REVISION: OVERSIGHT CONCERN - DATED FEBRUARY 23RD, 2022
SHEETS: A102, A103, A105, A200, A201, A203, A204, A300, A4.03

NO.	DESCRIPTION	DATE
1	REVISED AS PER CITY COMMENTS - DP	2021-10-27
2	OVERSIGHT COMMENTS	2022-02-23

364 E 14TH STREET
DUPLEX INFILL
COVER SHEET

SECTION 1
1/4" = 1'-0"

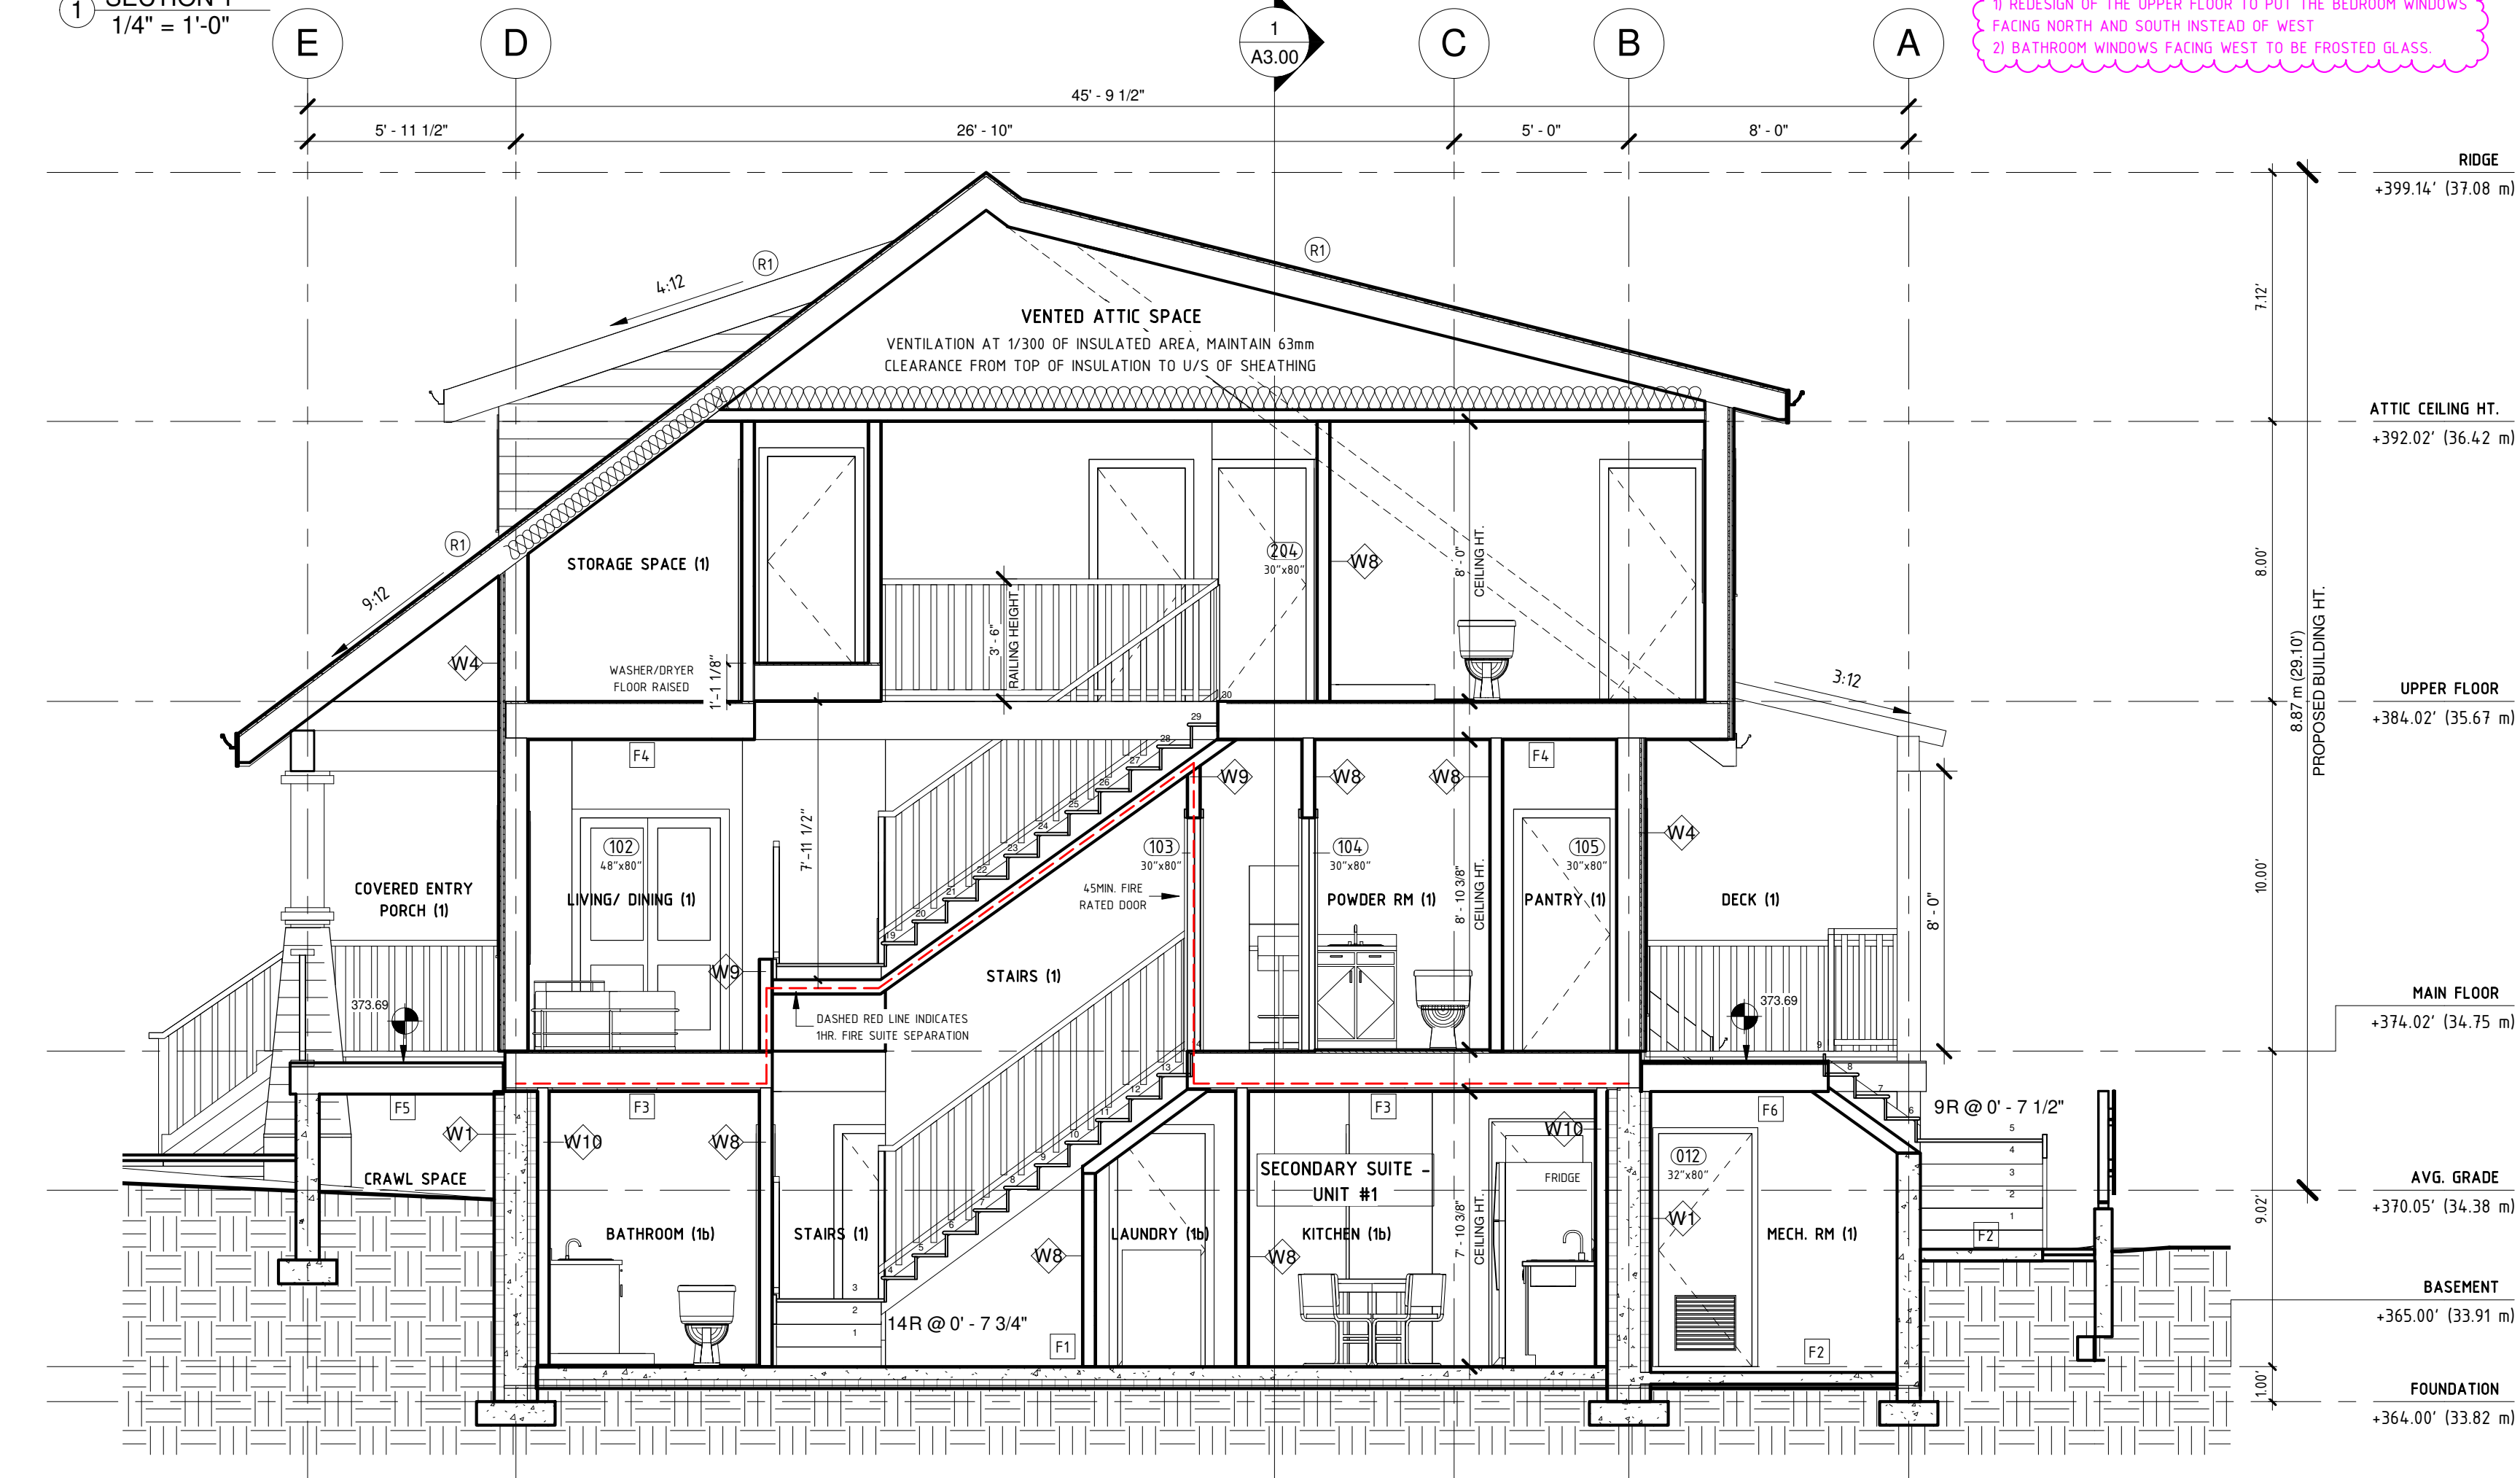
REVISION:
1) REVISION OF THE UPPER FLOOR TO PUT THE BEDROOM WINDOWS FACING NORTH AND SOUTH INSTEAD OF WEST
2) BATHROOM WINDOWS FACING WEST TO BE FROSTED GLASS.
